STAFF REPORT: JUNE 12, 2024 MEETING

APPLICATION NUMBER: HDC2024-00181

ADDRESS: 441 W. WILLIS

SCOPE: ERECT MULTI-FAMILY BUILDING

Streetscape view, looking west on W. Willis. Subject property is denoted by the metal fence at bottom left (★). There are two dominant wall materials for each building on this block: brick and stone.

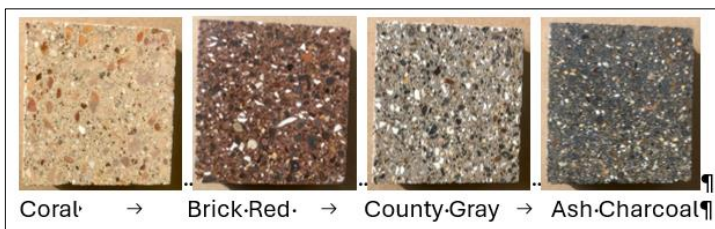
There is a vast difference in usage of materials and colors for the proposed structure, in comparison with the color palette and materials used on the district’s historic-age and contemporary buildings.

Staff’s concern is how the multiple cladding materials relate to the district as well as to each other. In contrast to the above streetscape photo, which shows two dominate wall materials and colors per building, the subject property has four wall materials and seven colors.

- One color will be used for the masonry element. This will significantly reduce the number of exterior colors on the building to be compatible with the dominant two-color palette of the existing buildings in the district.
- The traditional-sized CMU blocks are atypical materials for residential structures in this historic district and are not compatible with the profile, dimensionality, and appearance brick. Therefore, brick-sized CMU ground-faced blocks with the terrazzo-like finish can be considered, as can brick.
- The elements discuss the dominance of repetitive openings on facades. The large picture window breaks from the repetition and proportionality of the single and mullioned window openings. Fabricating a central mullion and installing two casement or fixed windows will create a similar verticality for this opening on the façade.

Left: Photo from Echelon Masonry’s Facebook page. Rows of Trendstone Plus units are identified with blue stars. This example shows the product in a size different than proposed by the applicant and is very likely “44F” (shown below). It is used as an alternating course with traditionally sized CMU.

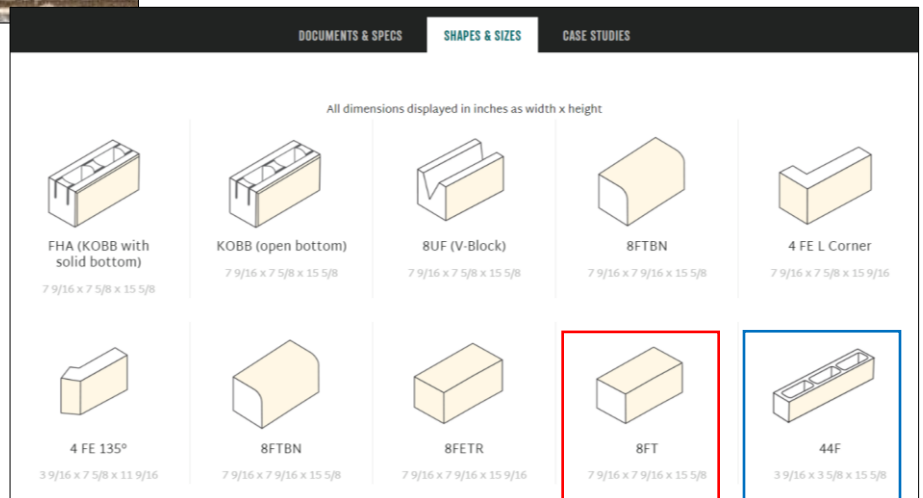
Trendstone Plus – architectural “ground face” CMU (concrete masonry unit) – which, according to the company’s website, is an integrated color product that’s polished to a smooth terrazzo-like finish. “Ground face” describes how the product is ground on its face to expose the aggregate.

It appears the company offers two dimensions of blocks: traditionally sized concrete blocks (similar to nominal block sizing of 8” deep x 8” high x 16” wide) and a narrow block (approx. 3-1/2” deep x 3-1/2” high x 15-1/2” wide) that offers a similar proportionality to Roman brick. The photo below shows both products together, offering a clear dimensional contrast between the two units. The applicant submitted samples of this product so the Commission can review the proposed colors and “terrazzo-like” surface finish.

The applicant selected the traditionally sized concrete block for the building, however the applicant calls it “stone veneer”. It is staff’s opinion that CMU walls are monolithic in appearance, even when multiple colors used, and the Commission has consistently denied the use of concrete block for exterior walls of residential buildings. As described in the Elements of Design, brick is the most common wall material, and this material translates well to contemporary designs and offers varied visual qualities, textures and brick patterns.

Details of enclosure.

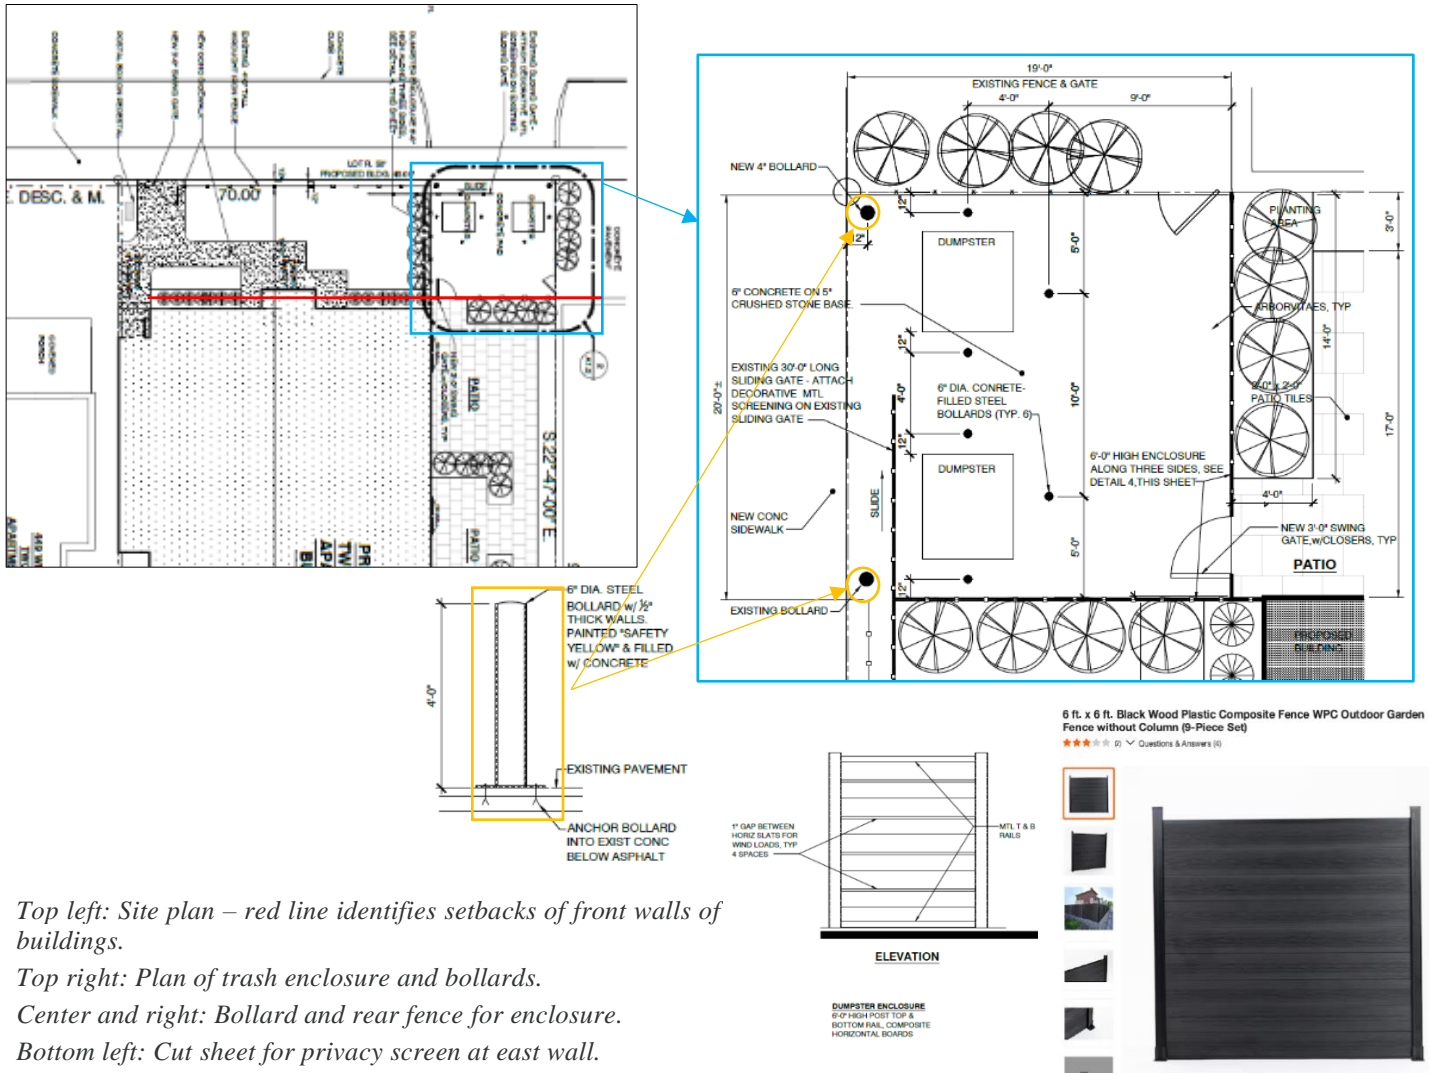
The placement and design of the garage enclosure, however, is not appropriate for this location and setting and does not meet Elements 12 and 13. The site plan shows the trash enclosure sits forward of the existing and proposed buildings. Additionally, three different wall materials are proposed for the four walled enclosure.

Front and East walls – The existing metal fencing and gates will remain as-is.

West wall - New metal fencing, to match the existing fence, will be installed. The applicant suggests attaching a privacy screen at this location. The product advertised in the cut-sheet is primarily used for jobs sites and tennis courts and is typically installed on chain link fencing. Color: green.

Rear wall – A 6'-0" plastic composite horizontal board fence will be installed. The shine and flatness of the manufactured material does not adequately match the profile, dimensionality, and appearance of wood or metal, the most common materials used in fencing and is incompatible for use in the historic district (and is in conflict with *Element 7 – Relationship of Materials* and *Element 8 – Relationship of Textures*).

The placement of this enclosure is incongruous to the district and destroys the site line of the streetscape and landscape. The use of three different fencing designs further disrupts the visual space of this lot and residential street.

Denial – Trash Enclosure

Staff recommends that the proposed trash enclosure should not qualify for a Certificate of Appropriateness, as it does not meet the Secretary of the Interior's Standards and the Willis-Selden Local Historic District's Elements of Design:

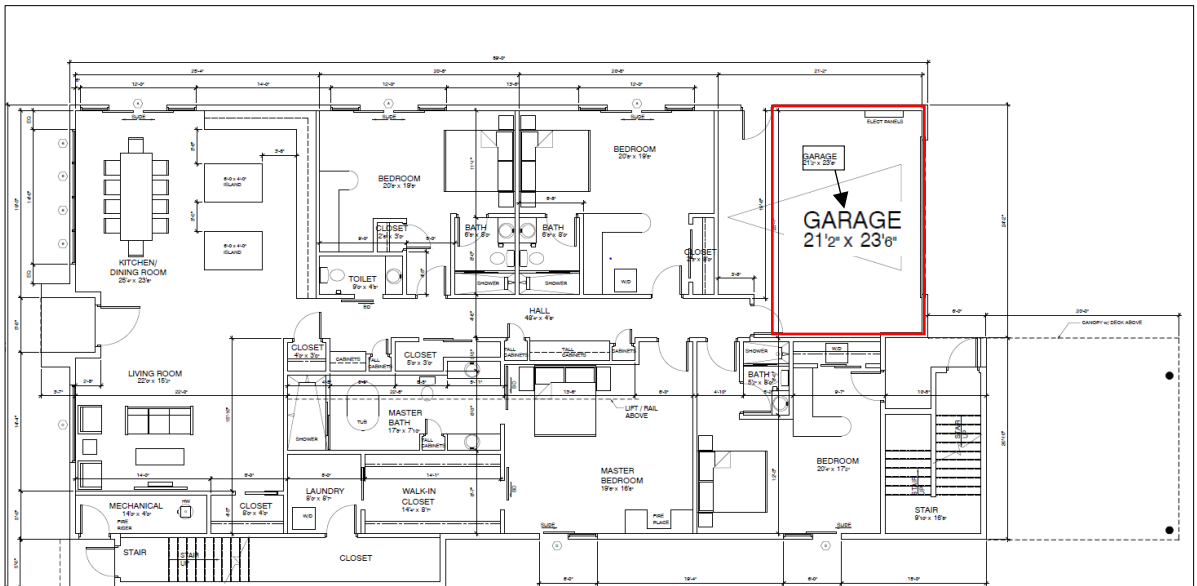
The proposal includes twelve surface parking spaces, but the application doesn't list the additional two indoor parking spaces designed at the back of the building (which are noted on the first floor's floor plan). Therefore, fourteen spaces are designed for the four-unit building. The applicant states zoning requires one parking space per unit and they wanted to achieve one space per bedroom. Counting the bedrooms: one four-bedroom unit, one three-bedroom unit, and two, two-bedroom units, there are eleven bedrooms in the building. It is staff's opinion the applicant could consider locating the trash enclosure at the top or bottom corner of the parking area, where it could open to the public alley. This would require the loss of probably two parking spots, but the project would stay within the goal of one parking space per bedroom.

Staff copied the space of the trash enclosure at the sidewalk to show how the trash enclosure at the alley could be accommodated by the reduction of two parking spots. This new location would require a redesign of the sliding gate parking lot enclosure; but more importantly, would keep the front yards and streetscape on Willis intact. In the 2020 new building application (site plan on page 2 of this staff report), the trash enclosure was proposed at the southeast corner of the rear lot.

Applicant elevation and rendering. The windows at 449 W. Willis are depicted as casements, but they are 1-over-1 double-hung units.

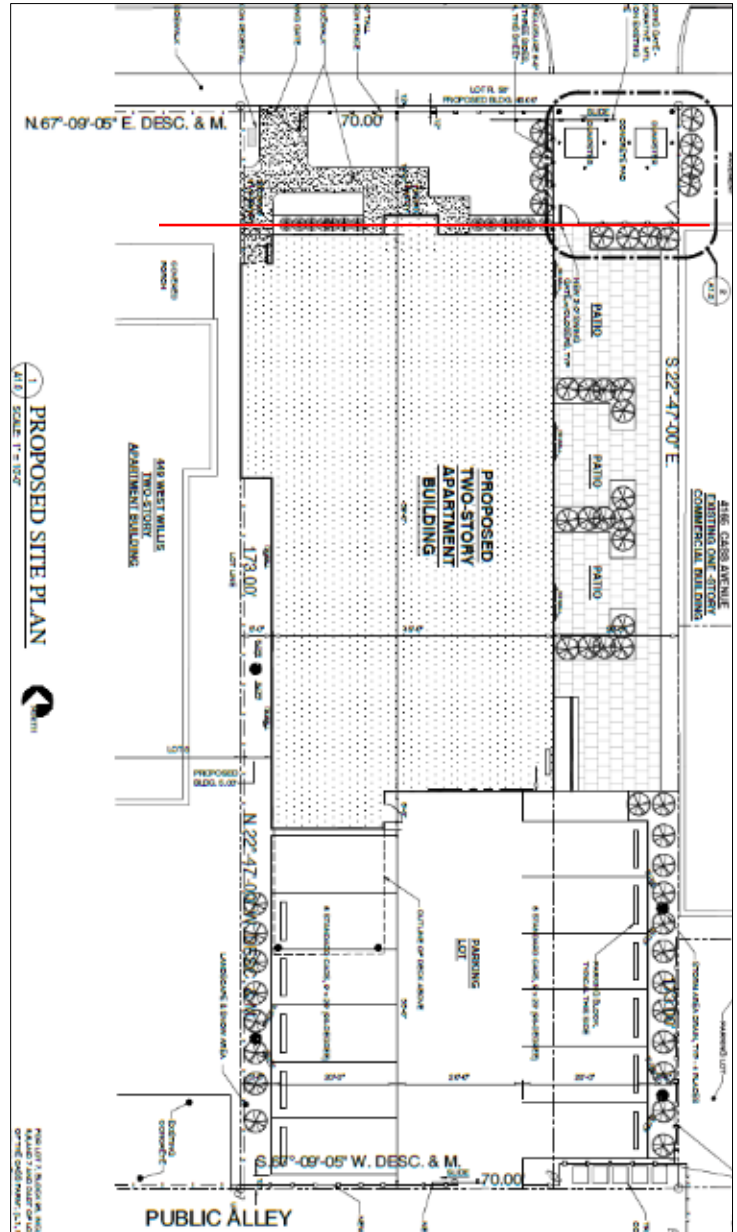
The 3-1/2- and 5-1/2- story apartment buildings (469 and 479 W. Willis) offer highly symmetrical designs, as does the 2-1/2 story dwelling (455 W. Willis). The balanced massing and consistent window/door openings are emphasized by singular contrasting window trim. At 449 W. Willis, the building next door to the subject property, the asymmetrical massing of the house is balanced by the vertical and horizontal alignment of the window and door openings. It should be noted the windows at 449 W. Willis are one-over-one double-hung units, as shown above. The applicant's renderings consistently incorrectly show these window openings as casement units without any divisions.

The proposed design includes vertically oriented window and door openings, similar to the surrounding buildings. The singular and mullied window openings create a uniform proportionality, with the exception of the large picture window. Staff recommends the large opening at the first floor be subdivided.

- The elements discuss the dominance of repetitive openings on facades. The large picture window breaks from the repetition and proportionality of the single and mulled window openings. Fabricating a central mullion and installing two casement or fixed windows will create a similar verticality for this opening on the façade.

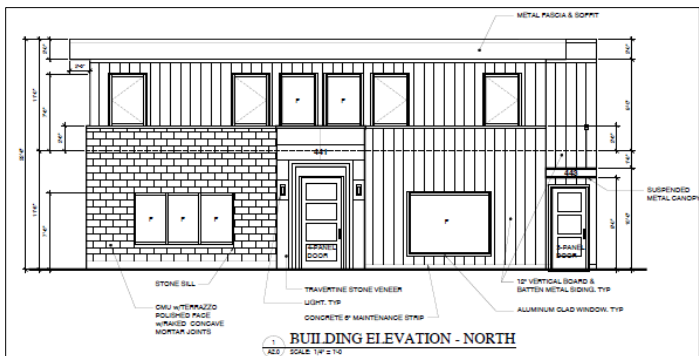
The picture window breaks from the repetition and proportionality of window openings, and the four colors used for the masonry element is not found elsewhere in the district.
